NOTE:
THIS RED LINE SUBMISSION RELOCATES SOME OF THE ON-SITE UTILITIES, REMOVES BUILDINGS 10A, 10B, AND 10C, AND SHOWS THE LOCATION OF THE EROSION CONTROLS

COVER SHEET
SERVICE & SUPPORT AREA INFRASTRUCTURE FACILITY PHASE I

SDP-08-084

EROSION AND SEDIMENT CONTROL PLAN
SERVICE & SUPPORT AREA
INFRASTRUCTURE FACILITY PHASE I
TAX MAP: 41 GRID: 16 PARCEL: 123
ELECTION DISTRICT 5-05 HOWARD COUNTY, MARYLAND
SHEET 10 OF 14

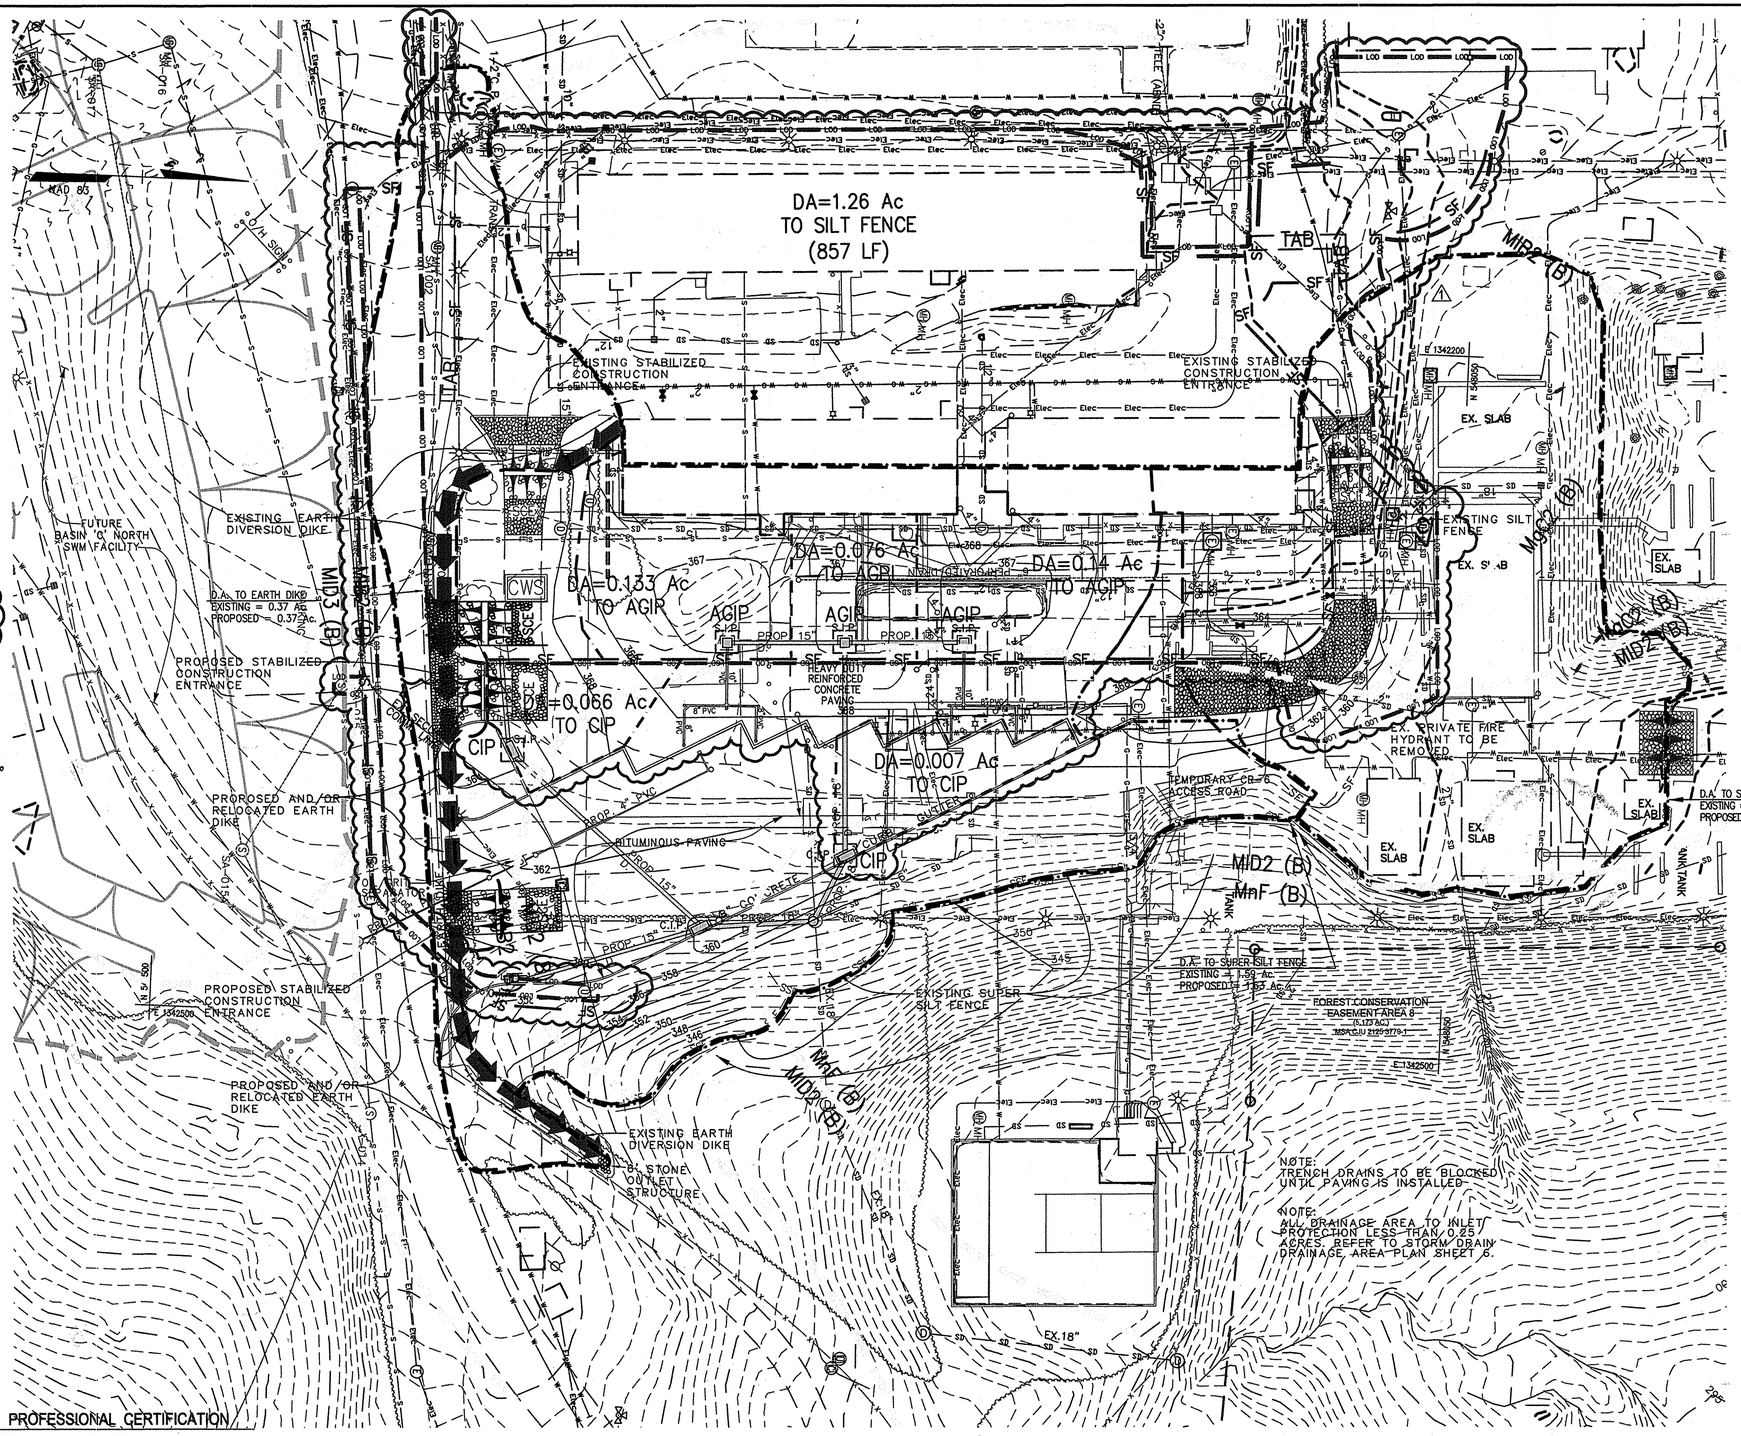
BY	NO.	REVISION	DATE
REB	1	SITE PLAN, UTILITY PLAN, AND EROSION CONTROL PLAN REFERENCES. RELOCATED SANITARY PROFILE. NOMINAL DIMENSIONS OF TEST BED RESEARCH FACILITY.	1/15/16
